**DATE:** July 26, 2024  
**PAGE:** 1 of 16 (INCLUDING THIS PAGE)  
**TO:** ALL CONTRACTORS  
**FROM:** DENISE KING  
**PROJECT:** NEW LOXLEY WATER TREATMENT PLANT  
FOR THE CITY OF LOXLEY  
GMC PROJECT NO. CMOB220078(2)  
**RE:** ADDENDUM #3

# ADDENDUM NUMBER 3

NEW LOXLEY WATER TREATMENT PLANT

- 2.1 Specification 40 71 13 – Magnetic Flow Meters has been revised and is included as an attachment to this addendum.
- 2.2 Drawings E-912, E-913, I-101 & I-601 have been revised and are included as an attachment to this addendum.

**1 NETWORK DIAGRAM**  
 E-912 SCALE: NTS

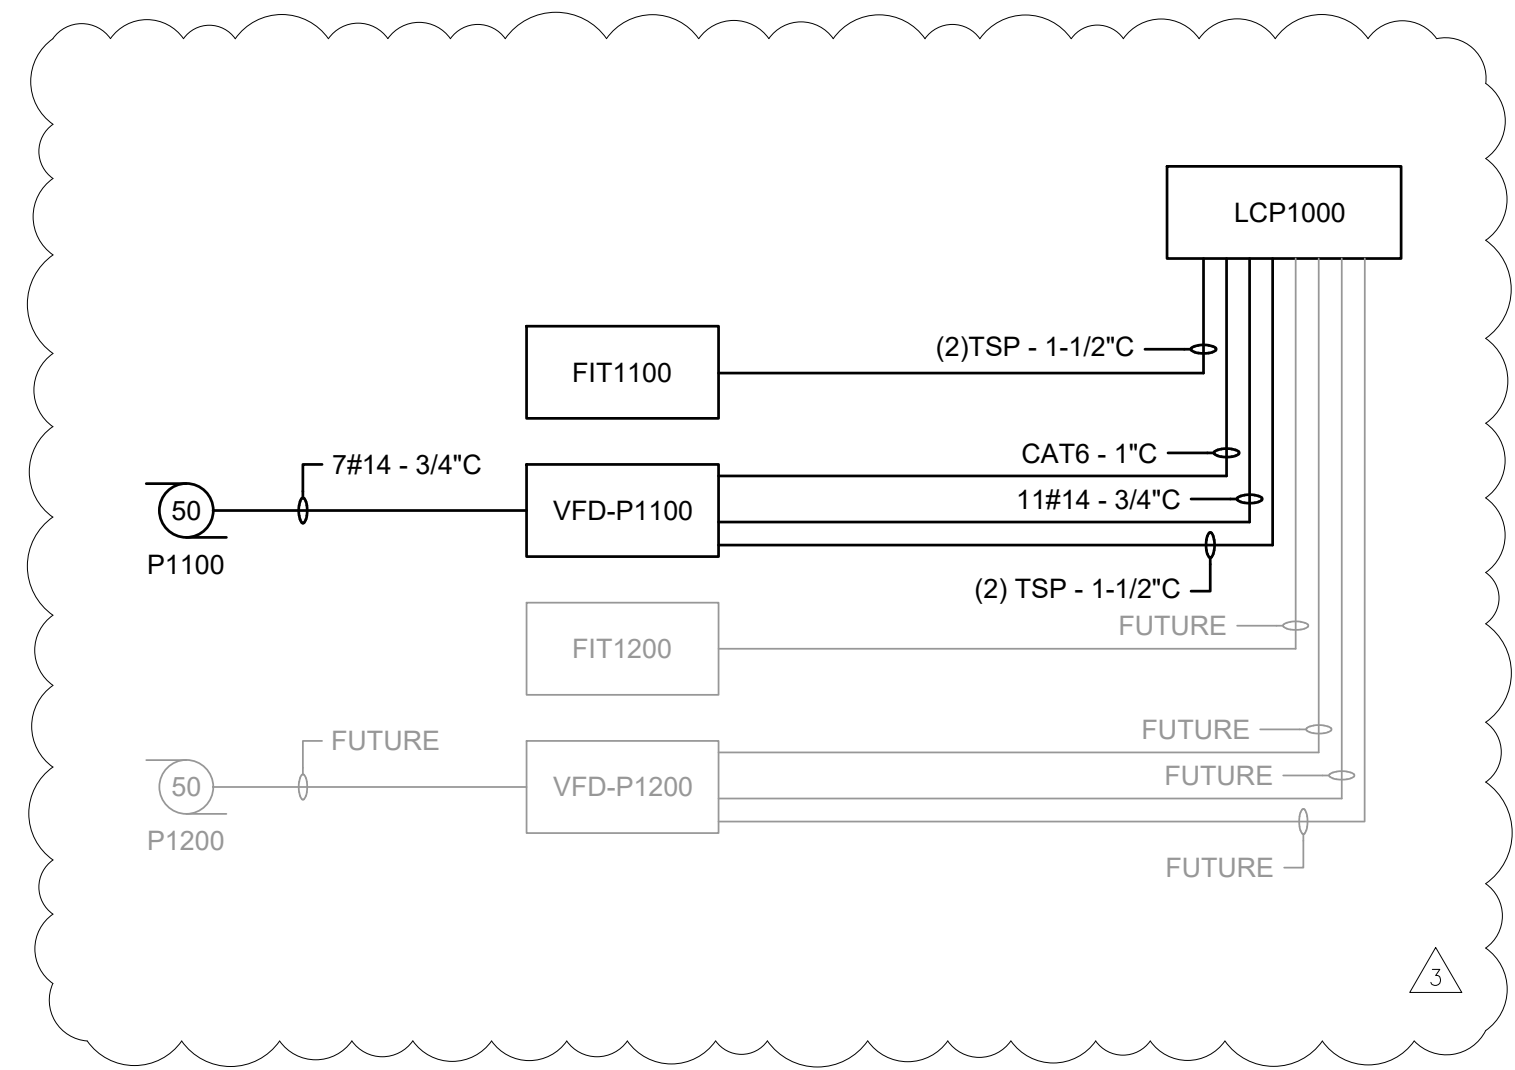
- 3.7 **Question: Project Plans SHT I-101 and I-102 show that Well VFD and Finished Water VFDs are to be monitored and controlled via ethernet only. With critical equipment it is advantageous to supply**

**hardwired connections in the event of a communication failure of any kind to still have monitoring and control over the motor. Please clarify intention to control if communication failure occurs.**

Answer: Revised electrical and P&ID drawings are included as an attachment to this addendum showing hardwired connections for VFDs for redundancy. Primary monitoring and control shall be via ethernet.

1. PRIMARY MONITORING AND CONTROL IS SHOWN AS MODBUS TCP VIA CAT-6. ESSENTIAL MONITORING AND CONTROL I/O SHALL ALSO BE HARDWIRED TO PRIMARY SCADA PLC IN LCP1000 FOR REDUNDANCY IN THE EVENT OF A COMMUNICATION FAILURE. SEE P&IDs FOR MORE INFORMATION.

E-913

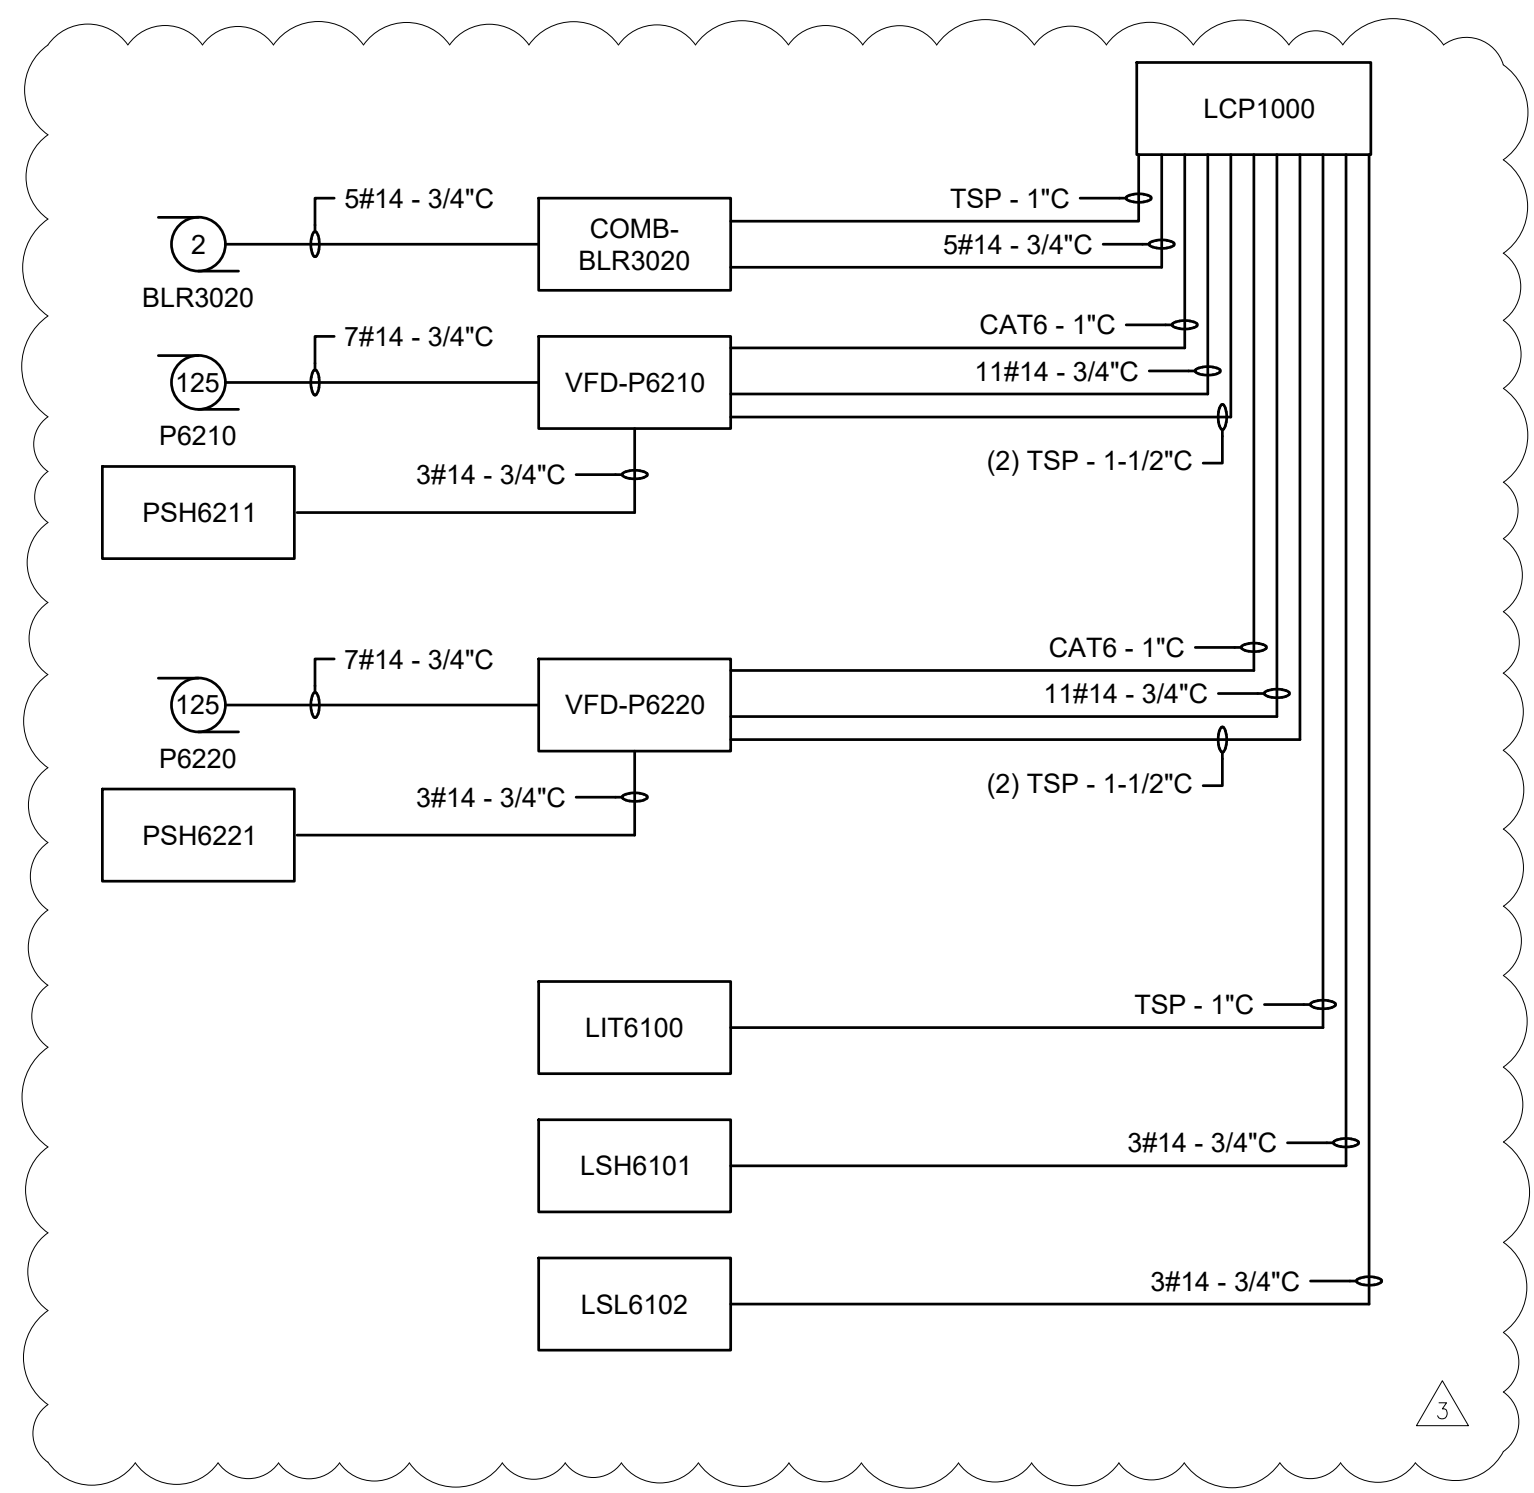
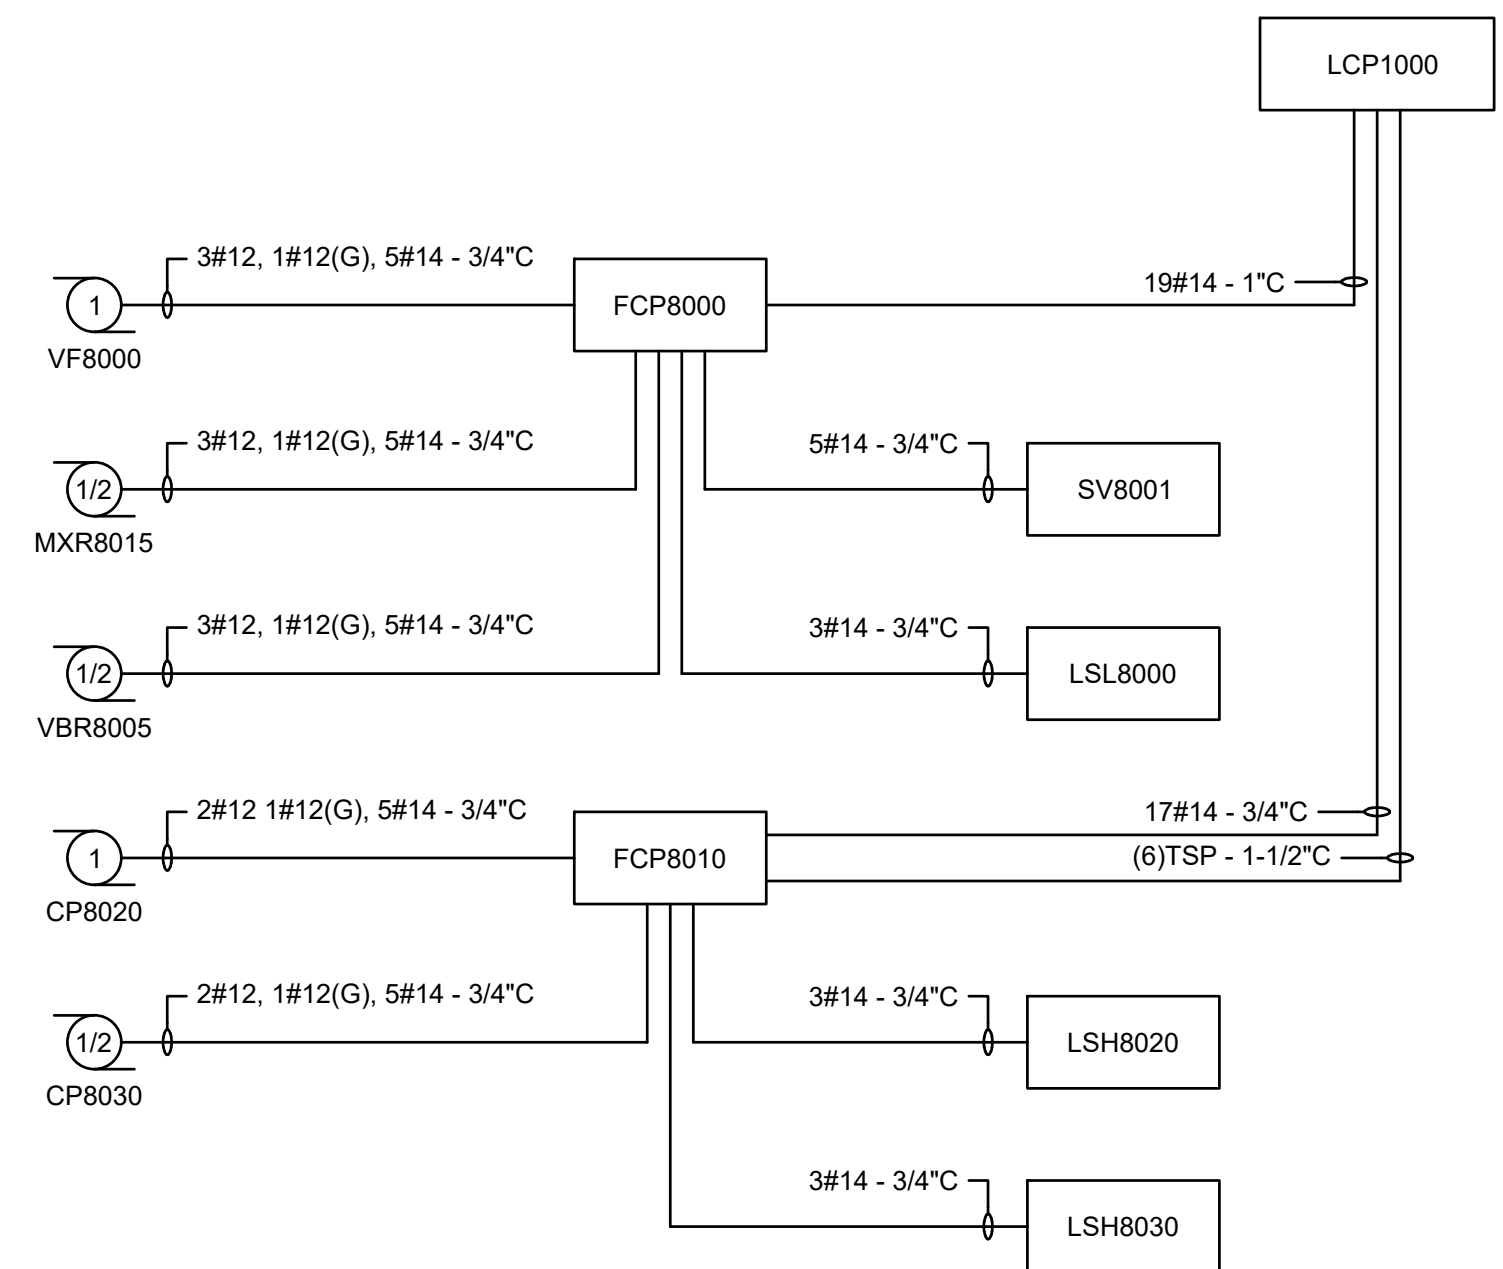
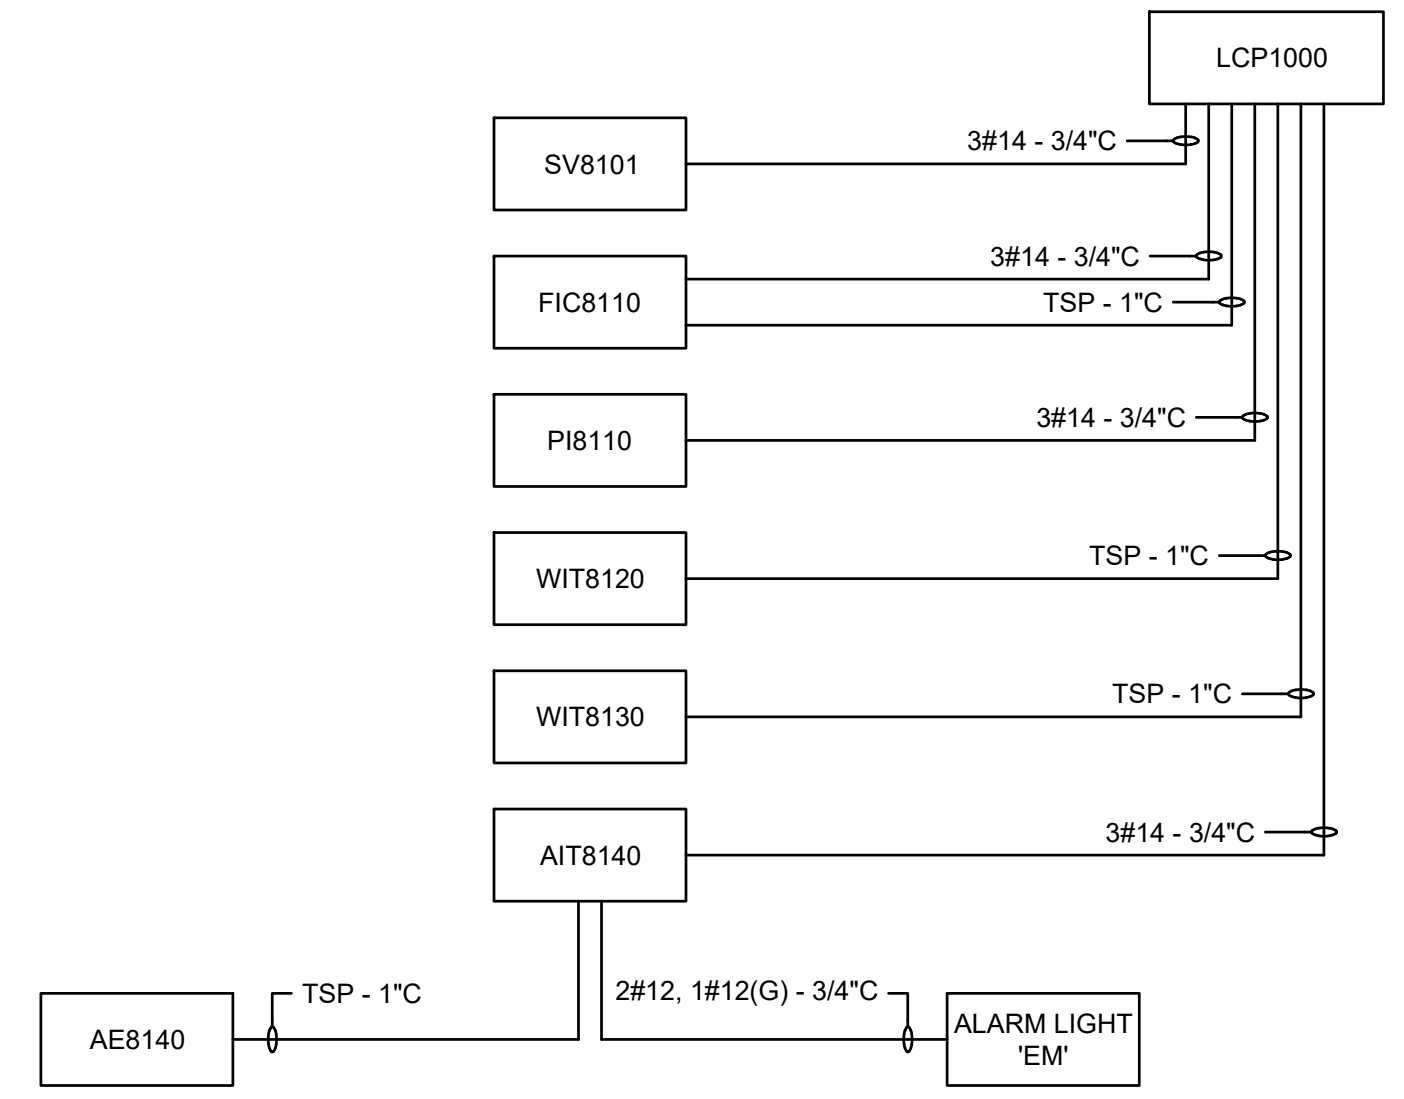
**3.8 Question: On Project Plans SHT I-811, the Chlorine Feed System is called out to receive a raw water flow signal. How is this accomplished?**

Answer: An analog signal from LCP1000 to the chlorine feed controller (FIC8110) is shown on the riser diagram on E-913 to flow pace the chlorine feed system.

1. PRIMARY MONITORING AND CONTROL OF WELL PUMP SHALL BE VIA ETHERNET. THE CONTROLS WITH AN ASTERISK (\*) SHALL ALSO BE HARDWIRED TO LCP1000 FOR REDUNDANCY IN THE EVENT OF A COMMUNICATION FAILURE.
